# Service Bulletin SB0048

**Date:** December 2002  
**From:** Capstone Technical Support  
**Subject:** 3-Way Valve Orientation on Air Assist Circuit

The diagram below shows the correct orientation of the 3-way valve.

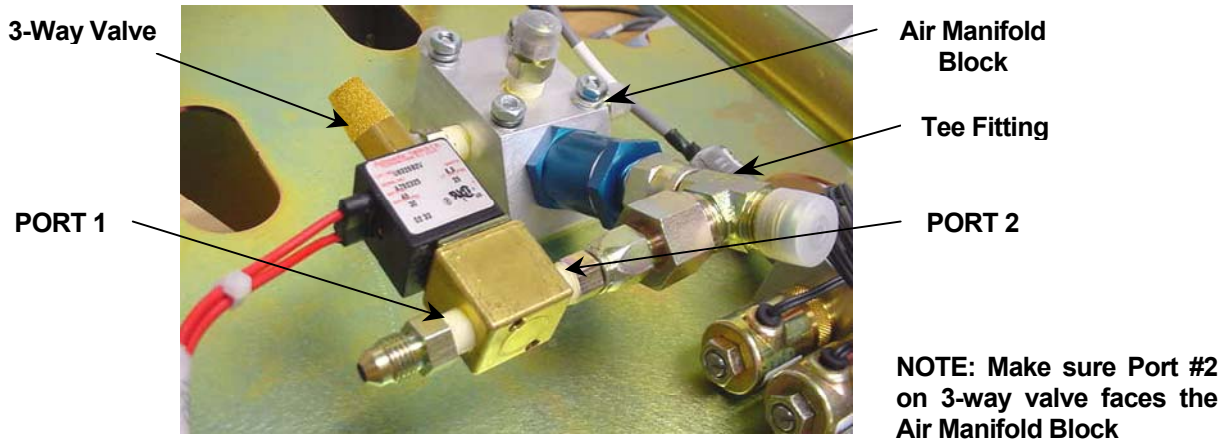
The air-assist circuit on the HEV liquid fuel version of the 30-kilowatt Microturbine may have been shipped with the 3-way valve installed incorrectly at the factory. If installed in the wrong orientation, the engine will not idle correctly and fuel injectors are more susceptible to clogging. All users of this version of the Microturbine need to inspect and correct this issue if the valve is installed incorrectly.

The 3-way valve can be installed in two different orientations. Visually examine and verify that the number two (2) stamped on the valve housing is facing the air assist manifold as shown in the picture. If the 3-way valve is installed incorrectly, the valve must be removed and correctly repositioned.

- 1) Detach the valve and fittings from the tee fitting connected to the air manifold block. Remove all pre-existing pipe tape thread from the fittings.
- 2) Rotate the valve so that port #2 (stamped on the valve housing) faces the air manifold block.
- 3) Carefully apply new pipe tape to each of the fittings, using caution not to extend the tape over the outer end of each fitting.

- 4) Re-install the fittings to the valve, maintaining the fitting locations as before. This is important, since the thread dimension is the same on both fittings, and it is possible to incorrectly reattach the fittings.
- 5) Re-install the valve to the tee fitting.
